# Horsley Witten Group

September 16, 2024

Re: 2<sup>nd</sup> Stormwater Peer Review  
Amendment for 140 Haverhill Street  
Andover, MA  
MassDEP File No. 090-1383

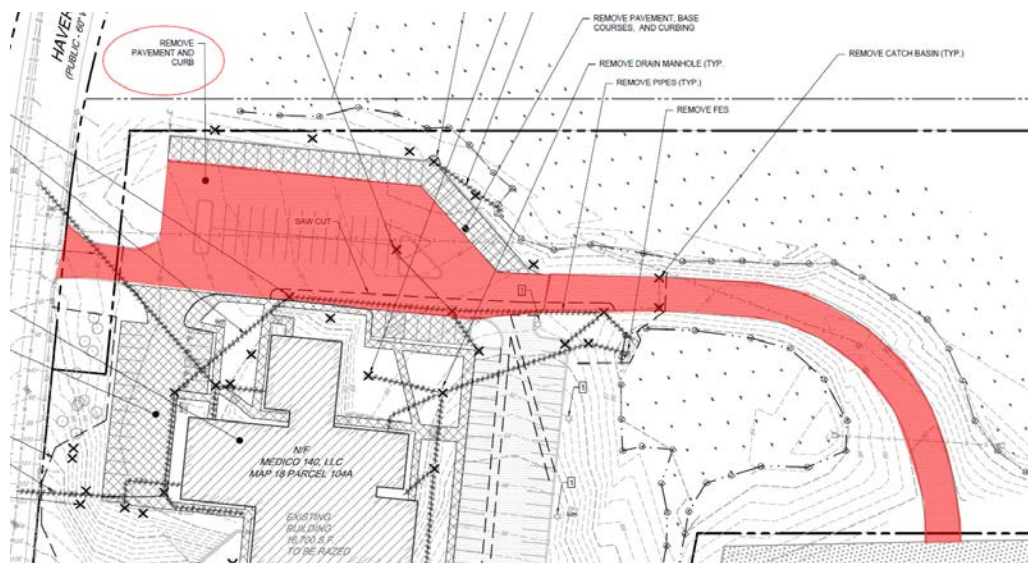
- b. It appears that the existing driveway on the north side of the parcel will be removed in accordance with the Demolition Plan. It is not obvious if this driveway will be repaved or replaced with loam and seed. HW recommends that the Applicant clarify the proposed plans for the northern driveway. If the driveway is removed credit for the reduction of impervious surfaces can be accounted for.

**September 16, 2024: The Applicant has stated that the area where the parking lot pavement is being removed is replaced with topsoil. HW was questioning the access driveway on the north side of the site. The Demolition Plan calls out to remove the pavement and curb for this driveway as highlighted in red in the image below. No further direction was obvious in the plan set. HW recommends that the Applicant clarify the proposed plans for the northern driveway.**
